***SVC Connection Equipment at Porcupine TS and Kirkland Lake TS
Notification of Conditional Approval of Connection Proposal
CAA ID # 2009-EX459***

Expedited System Impact Assessment Hydro One Networks

1.0 GENERAL DESCRIPTION & PROPOSED MODIFICATIONS

Figure 1 – Single Line Diagram for New SVC Connection at Porcupine TS

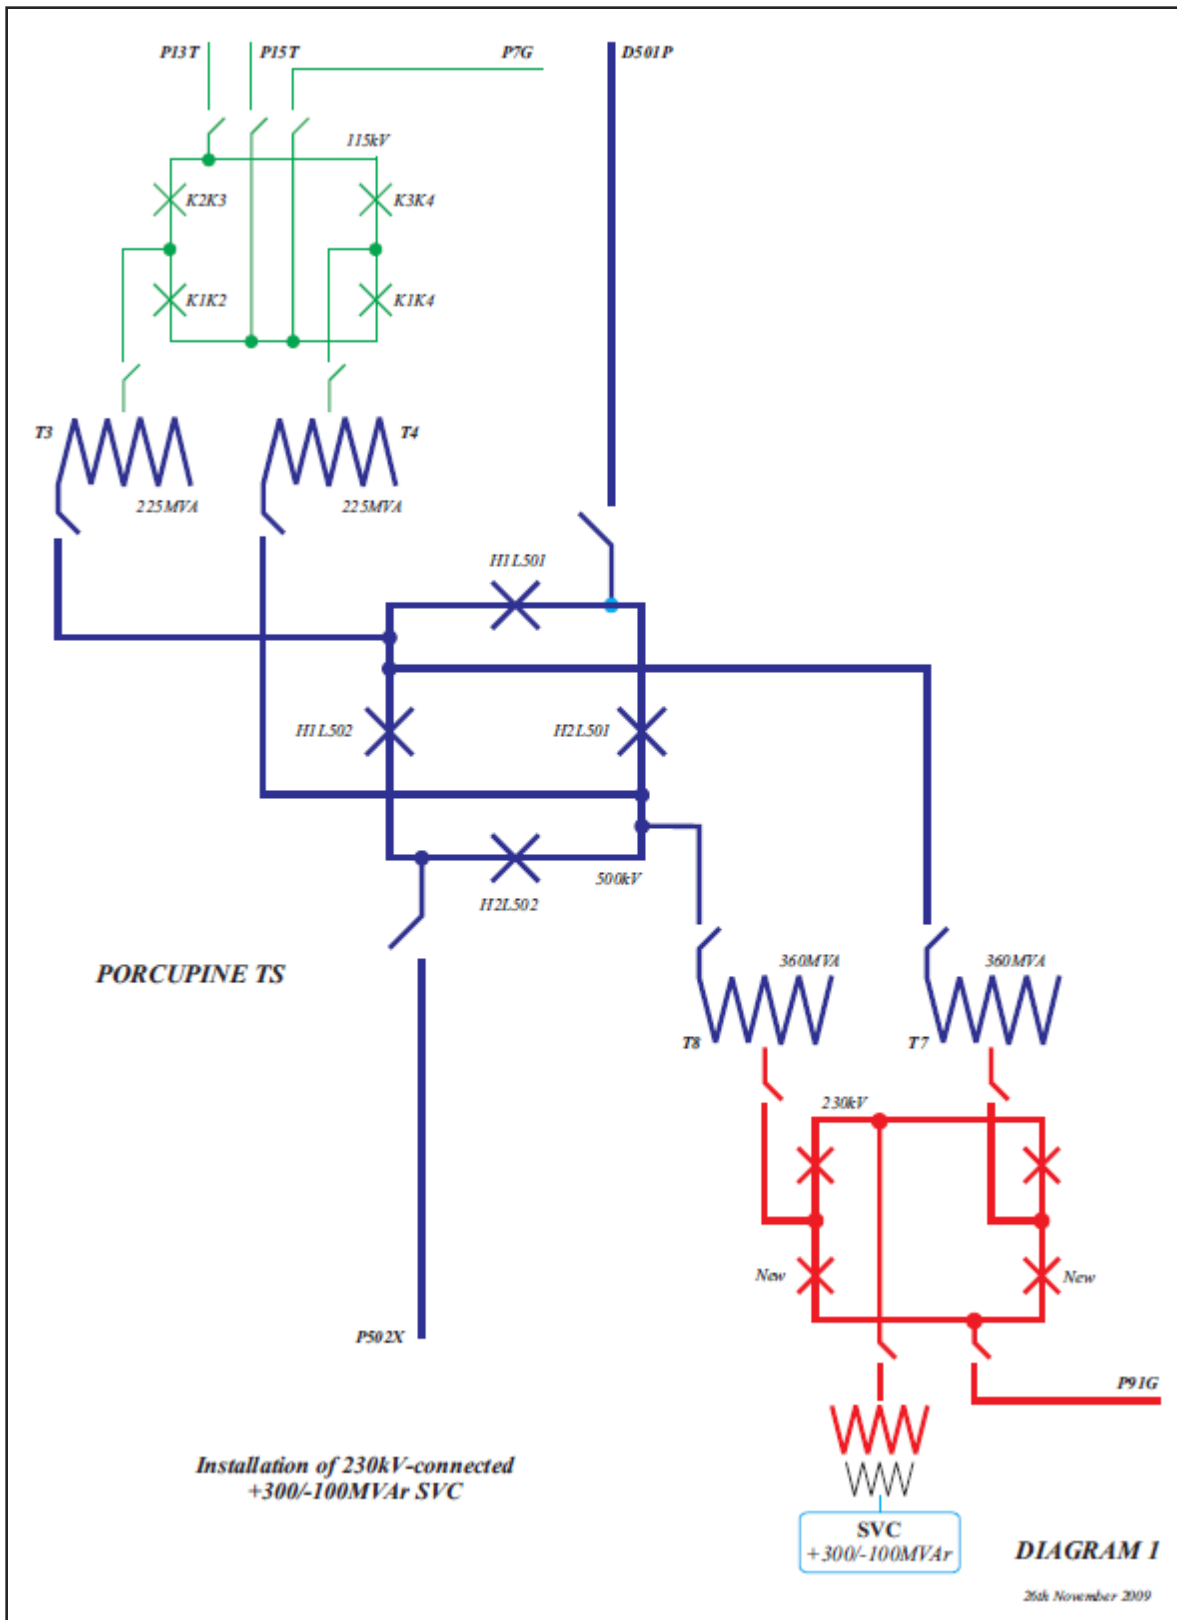
The proposed connection arrangement for the Porcupine SVC is shown in Figure 1. The work includes the installation of two new 230kV breakers; together with the associated disconnect switches, to provide a connection point on the 230kV busbar at Porcupine TS for the new coupling transformer for the +300/-100MVar SVC. Modifications are also to be made to the protective relaying, surge protection, communications, controls and metering.

Two new 230 kV breakers are to be installed at Porcupine TS to form a ring busbar. The existing 230kV circuit P91G is to be reterminated on to the position formed between the two new breakers, allowing the coupling transformer for the new SVC to be connected to the vacated position between the two existing breakers.

Figure 2 – Single Line Diagram for New SVC Connection at Kirkland Lake TS

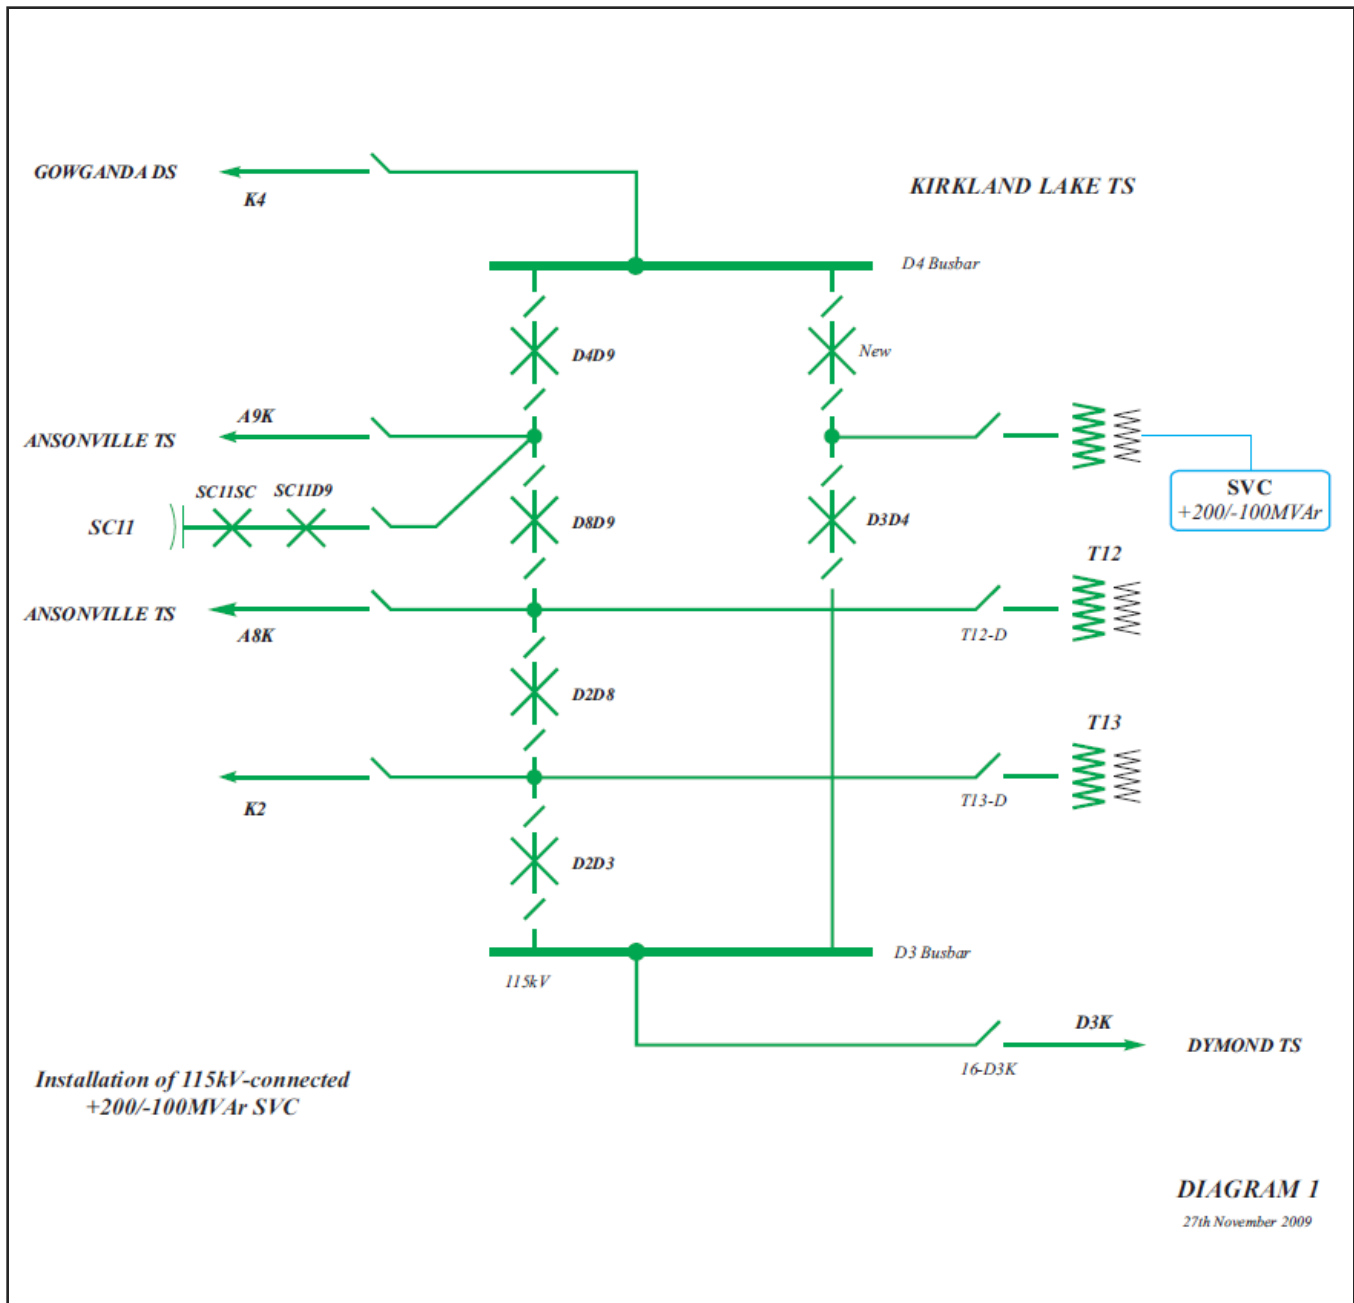
The proposed connection arrangement for the Kirkland Lake SVC is shown in Figure 2. The work includes the installation of a new 115kV breaker; together with the associated disconnect switches, to provide a connection point on the 115kV busbar at Kirkland Lake TS for the new coupling transformer for the +200/-100MVar SVC. Modifications are also to be made to the protective relaying, surge protection, communications, controls and metering.

One new 115 kV breaker is to be installed adjacent to the existing D3D4 breaker in the ring busbar at Kirkland Lake TS. The coupling transformer for the new SVC is to be connected to the position created between the new breaker and the D3D4 breaker. The technical specification for the new breaker is given below.
